AGENDA
REGULAR MEETING OF THE
WINDSOR HEIGHTS
PLANNING AND ZONING COMMISSION
Wednesday, October 23, 2024 - 5:30 PM
WINDSOR HEIGHTS COUNCIL CHAMBERS - 1133 66th ST
ZOOM: <https://us02web.zoom.us/j/7832856334>
Meeting ID: 783 285 6334

Date: October 23rd, 2024
To: Windsor Heights Planning and Zoning Commission
From: Trey Rouse
Subject: Site Plan: 6301 University Avenue – Windsor Presbyterian Church

Subject: Site Plan: Windsor Presbyterian Church Parking Lot Expansion (6301 University Avenue)

2nd Comment Letter

UTILITY PLAN

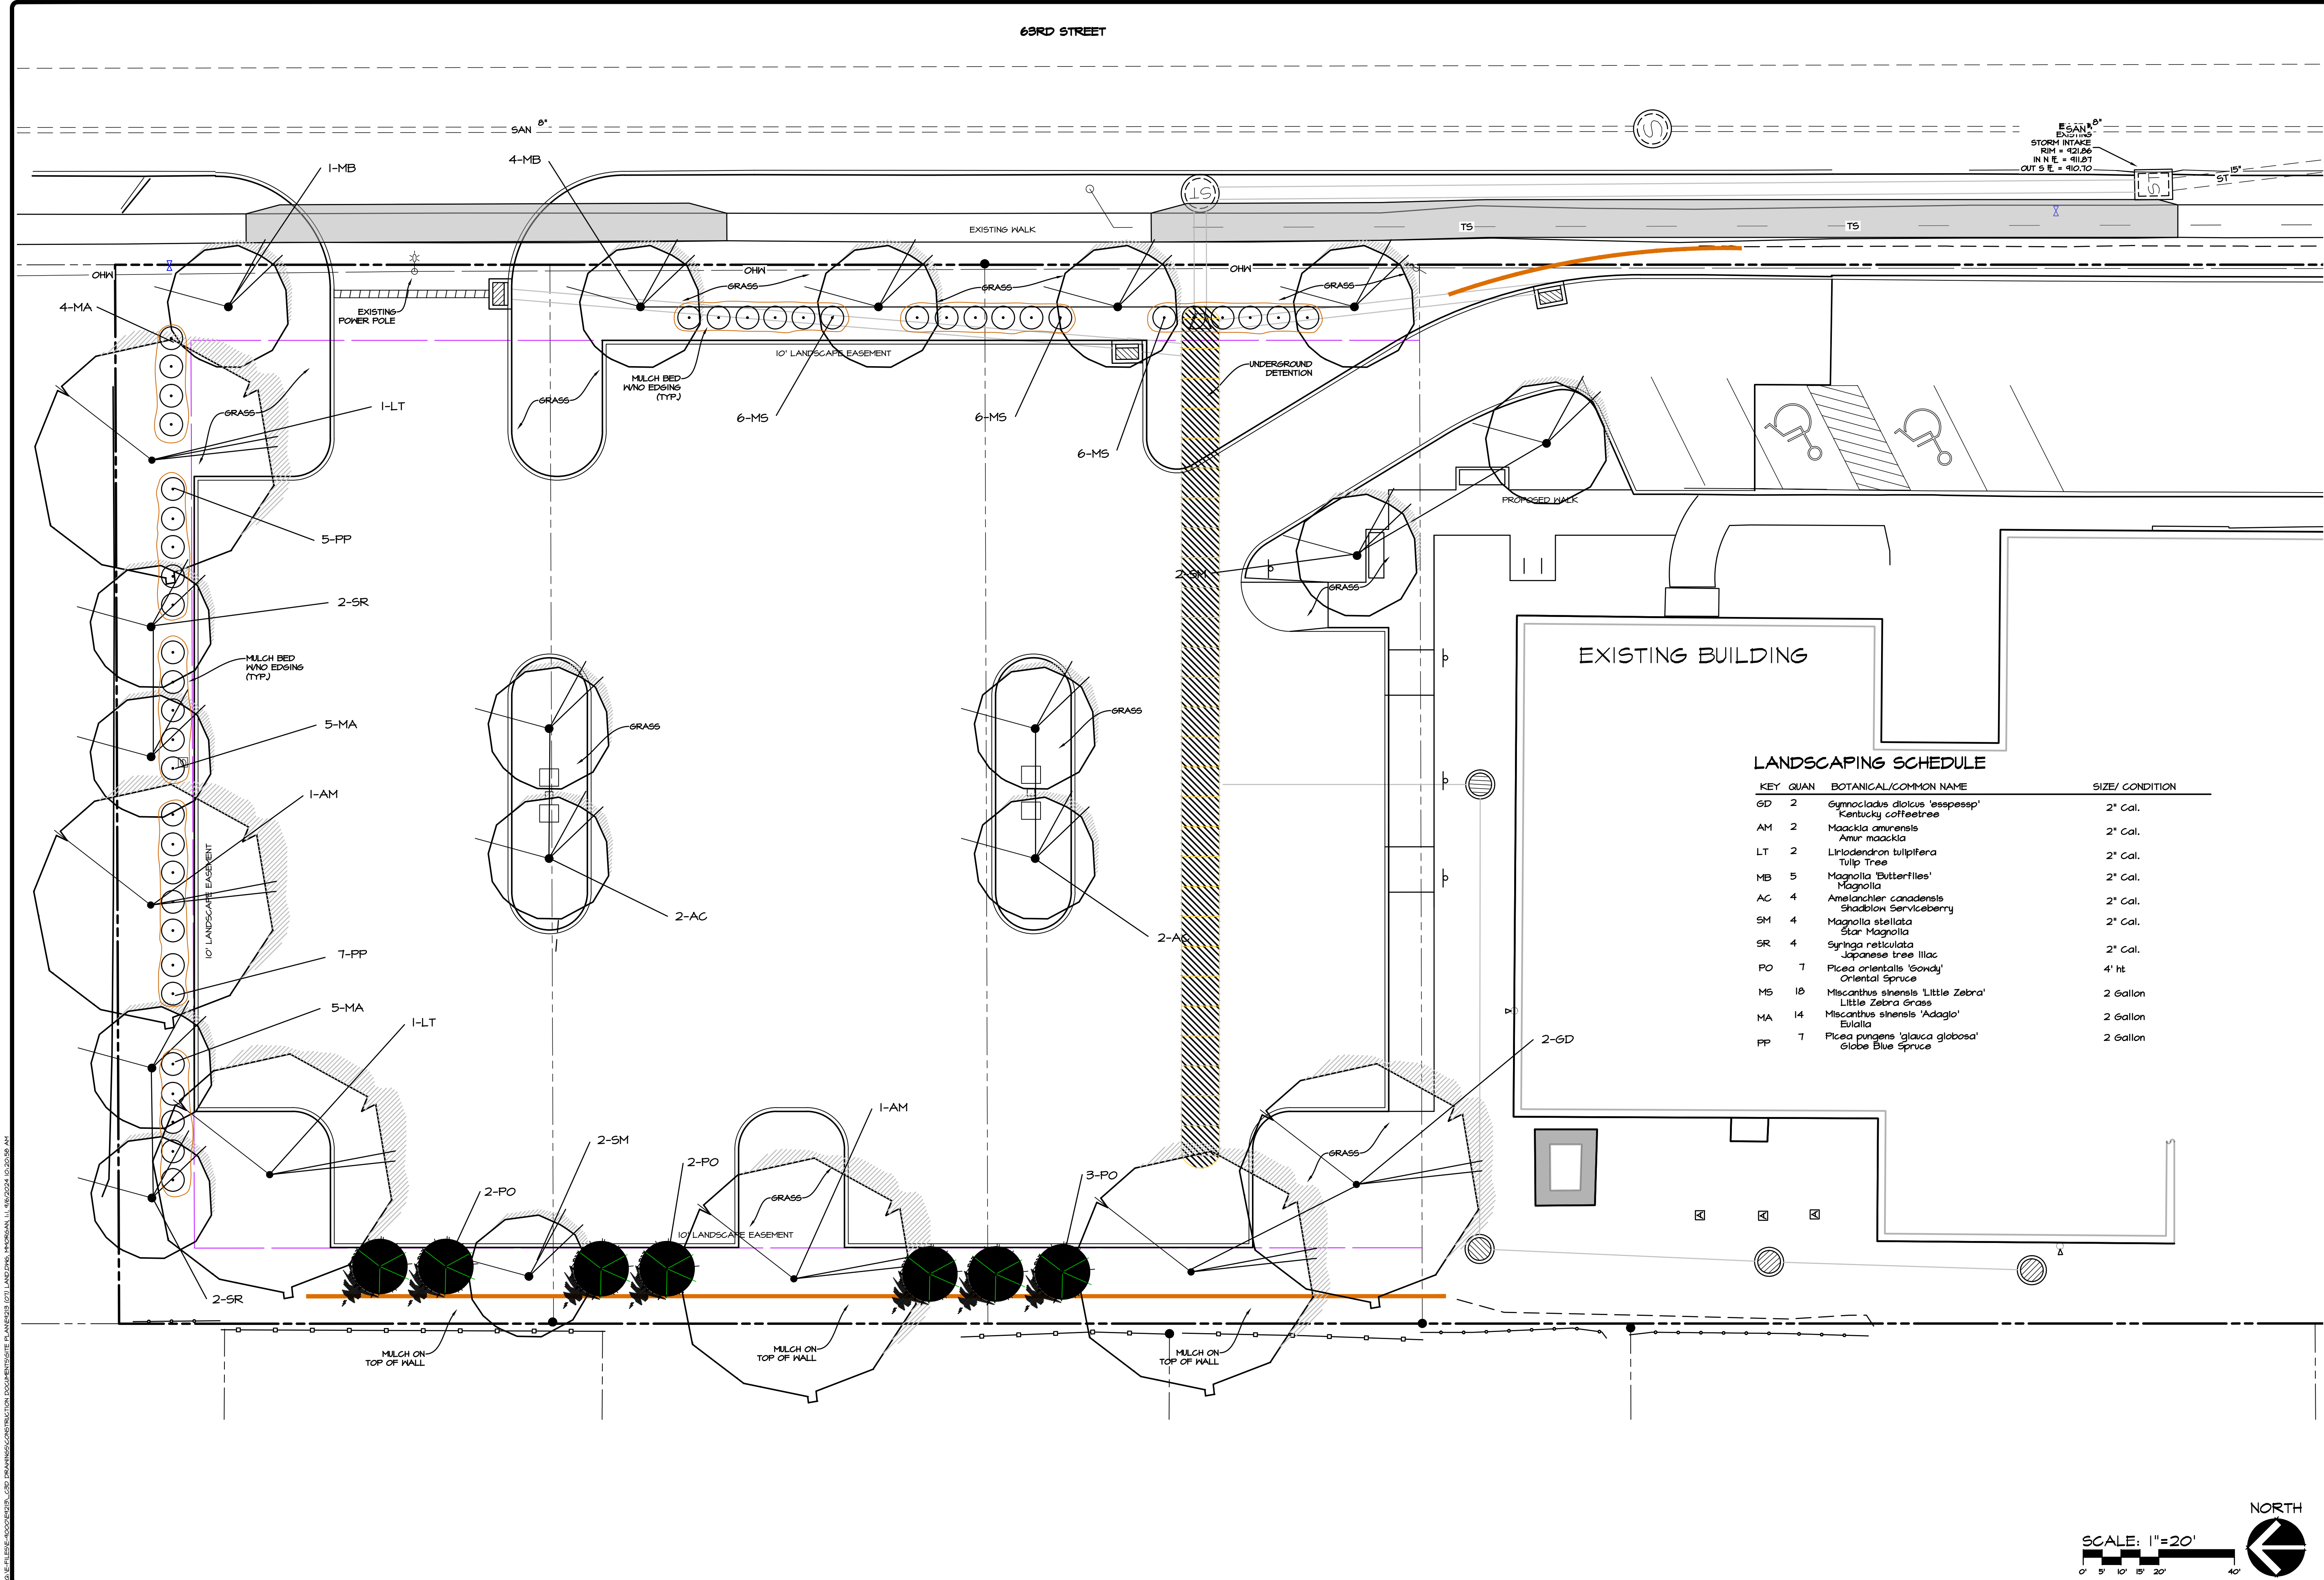
3. Plans underground storage chamber outlet pipe does not reflect what is in the Storm Water report.

PLANS UPDATED TO REFLECT SWMP

**DECIDUOUS TREE
PLANTING AND STAKING DETAIL**
NO SCALE

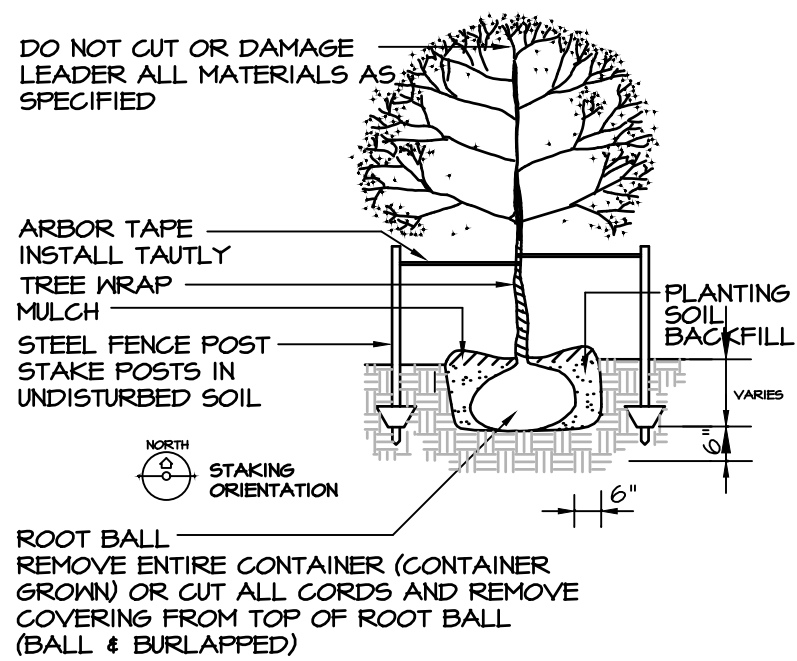
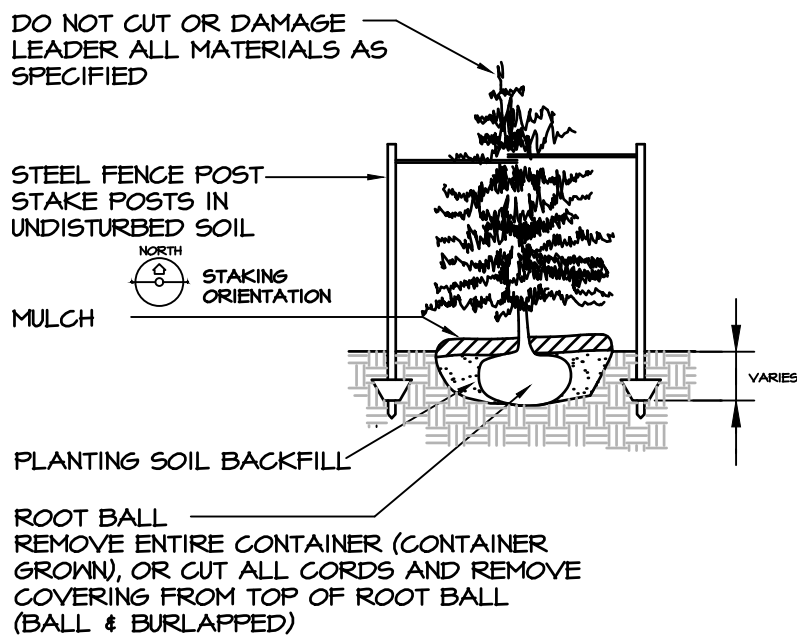
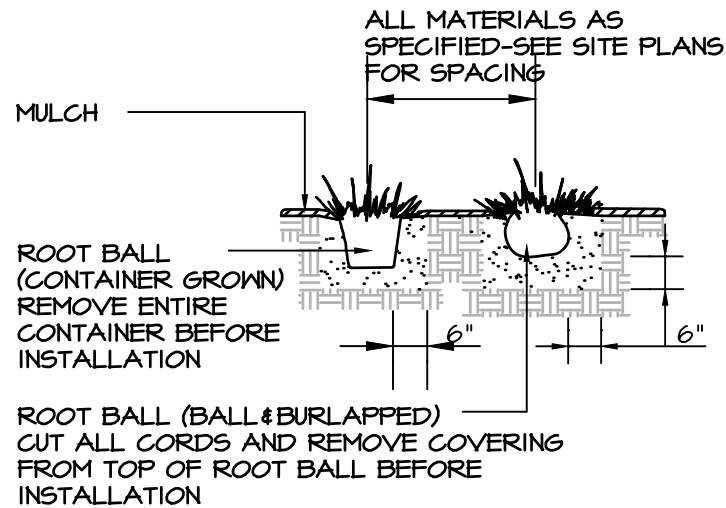
5. Provide planting details. (173.03) **ADDED**
6. Traffic General Comments
7. The driveway location on 63rd Street has increased from 175-feet to 325-feet from University which has moved the driveway further from University and the intersection influence area of the 63rd/University signal which a good thing, however, this driveway will be full access now with close proximity to University Avenue and may not be supported by the Iowa DOT. **SUBMITTED TO THE DOT**

WINDSOR PRESBYTERIAN CHURCH 6301 UNIVERSITY AVENUE, WINDSOR HEIGHTS, IA	DATE:	04-06-2024
	DATE OF SURVEY:	APR. 22, 2024
	DESIGNED BY:	SJD
	DRAWN BY:	MM
PHOTOMETRIC PLAN	SHEET	OF 9
E9213

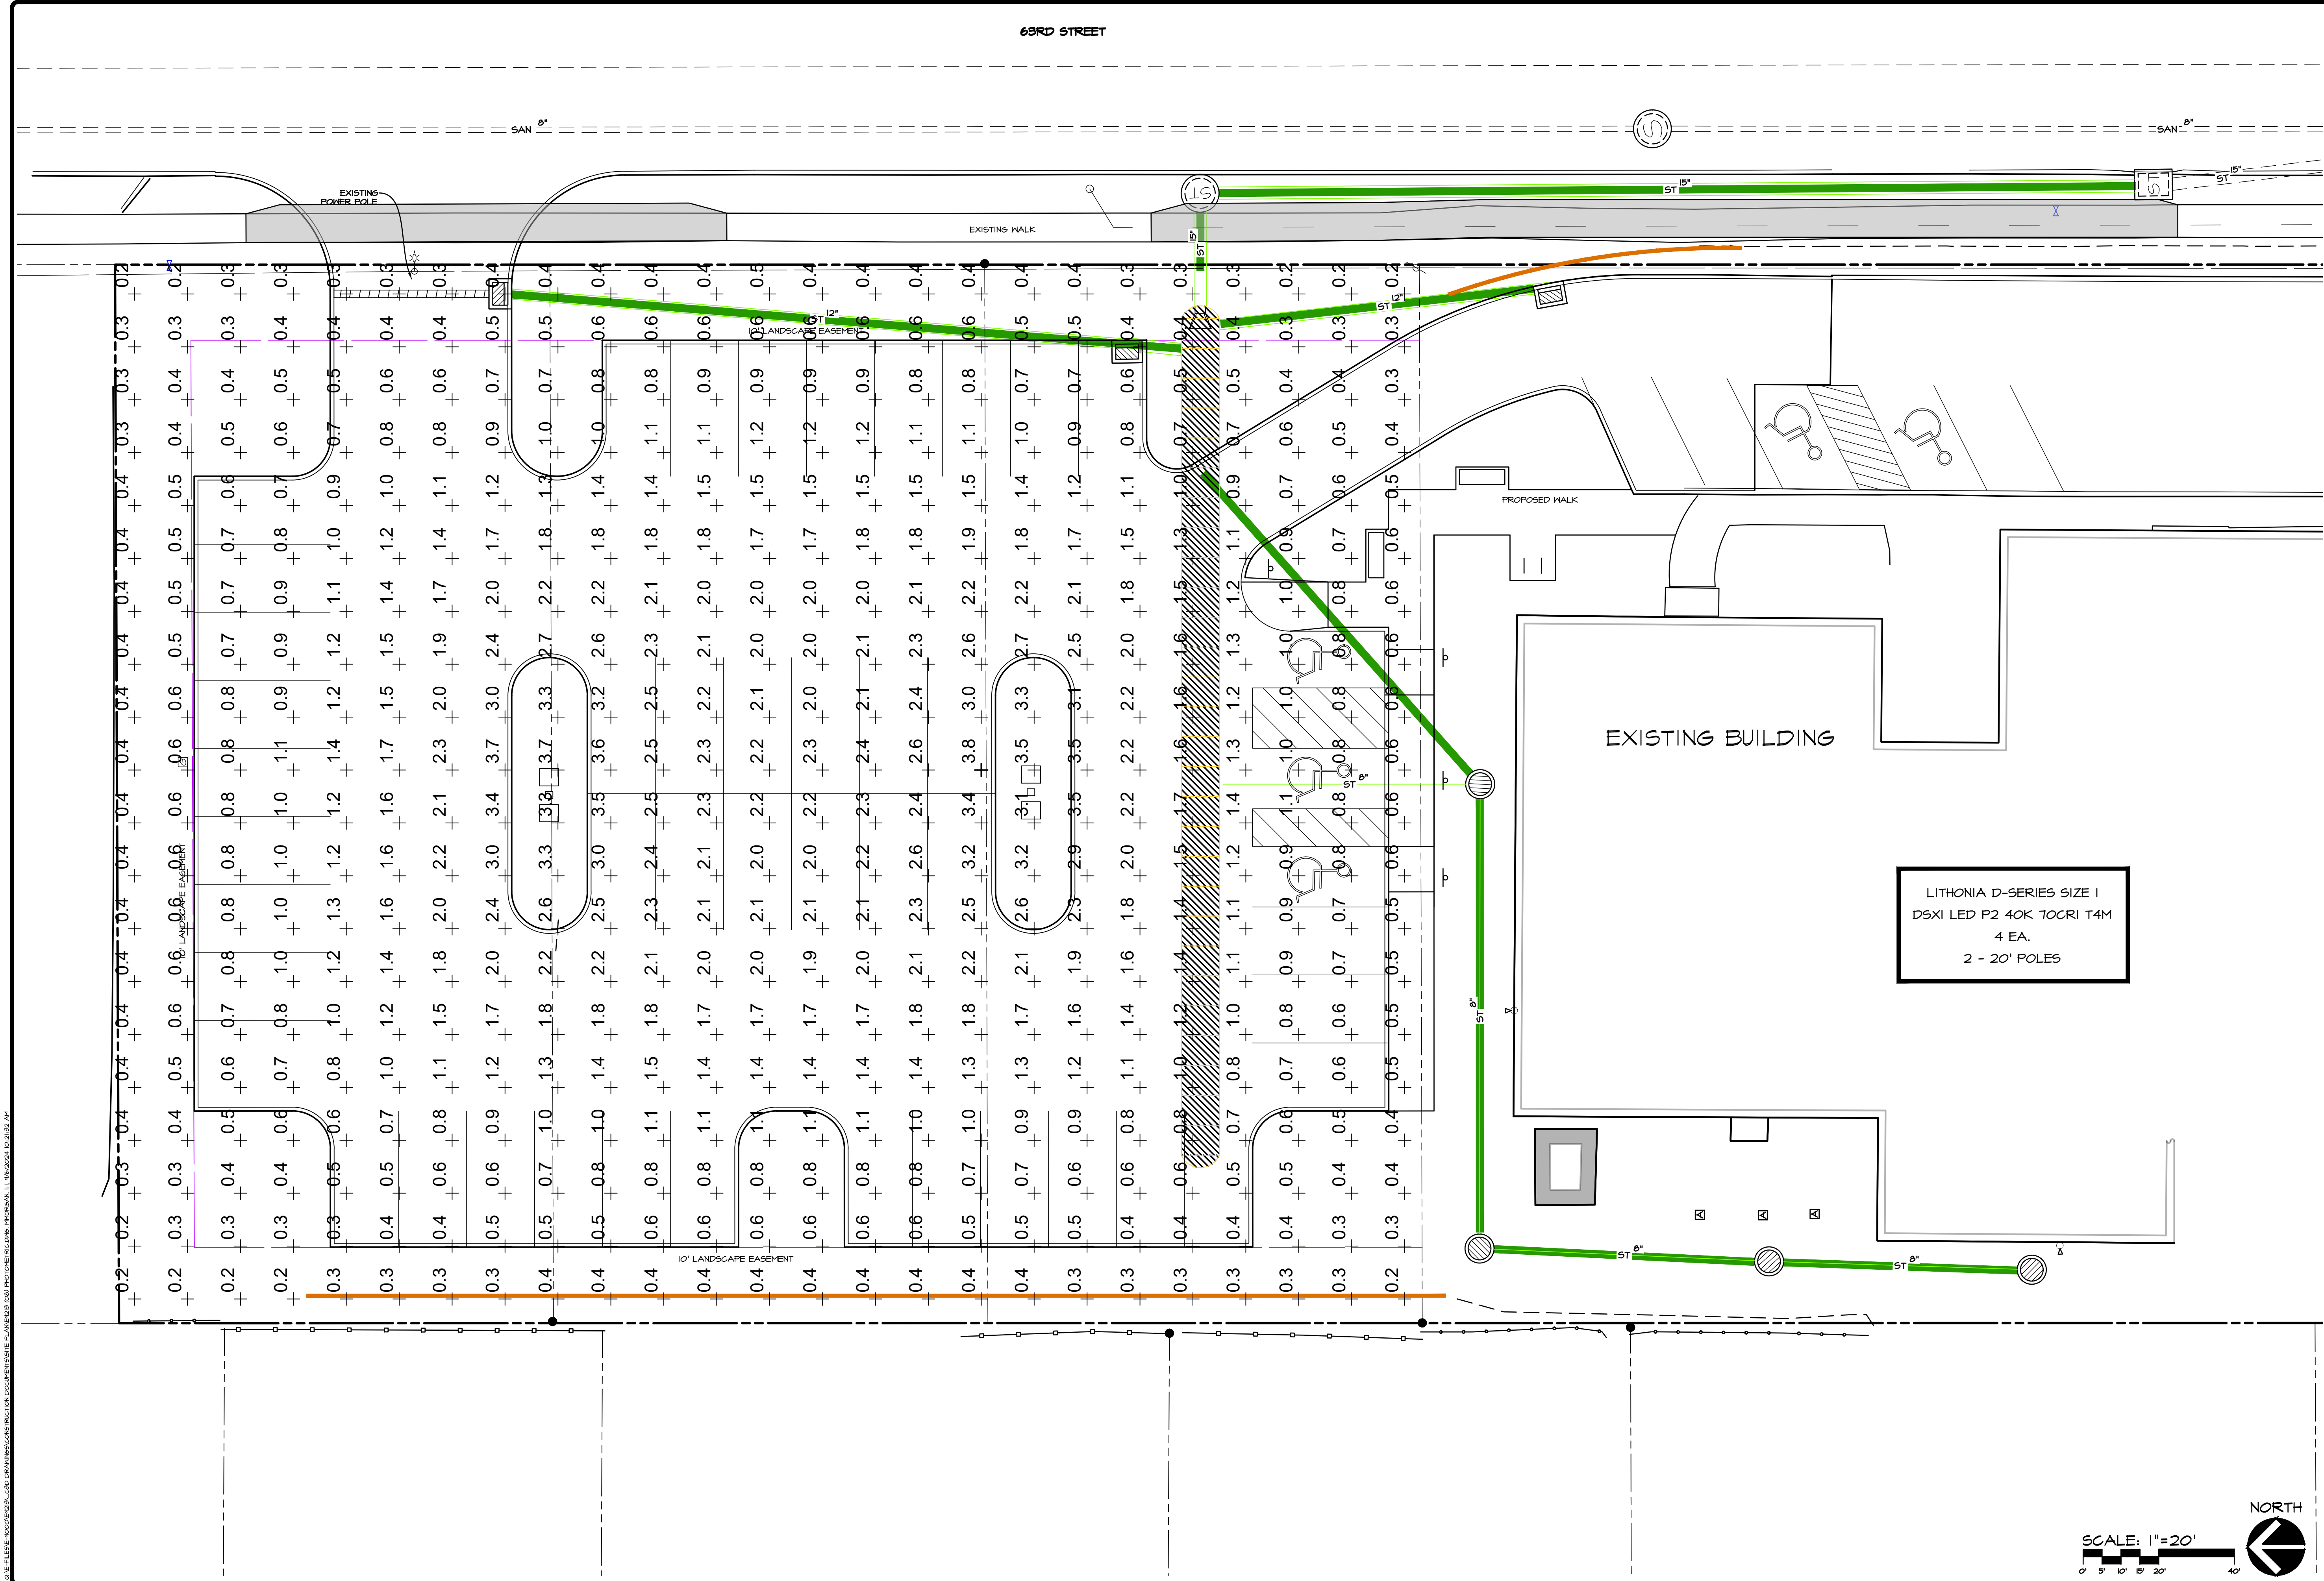
1. Submit lighting plan and photometrics. This is a repeat comment from the previous set. (170.10)
2. Provide a sidewalk connection on the east end of the south bay of parking stalls for pedestrian connectivity to the rest of the parking lot. (170.17) **ADDED**
